64 MT VERNON

PORTSMOUTH, NH

Stipulations for 64 Mount Vernon St. Shed Renovation

PROPOSED EAST ELEVATION 1/4" = 1'-0"

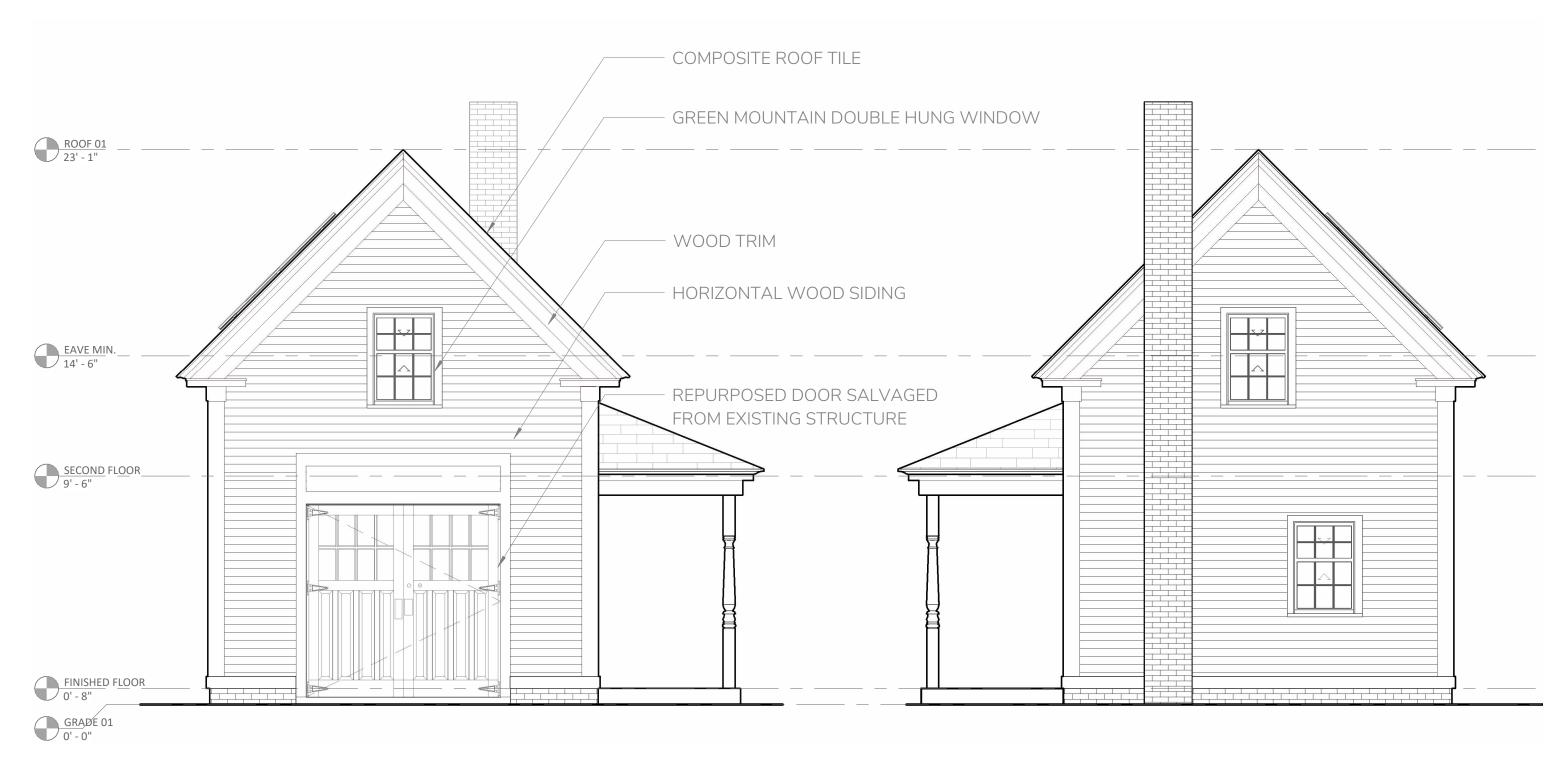
1. Windows

- a. All first floor windows will be Green Mountain double hung Milestone series 2624.
- b. The second floor windows will match the size of Green Mountain 2420 windows. The west side will be a Green Mountain DH Style Egress Window, which will look from the outside like a double hung, but open as a casement to meet fire code.

2. Chimney

The top of the chimney will be corbelled to match the house

3. Roof

The roof will be a composite slate similar to Inspire synthetic roofing tiles.
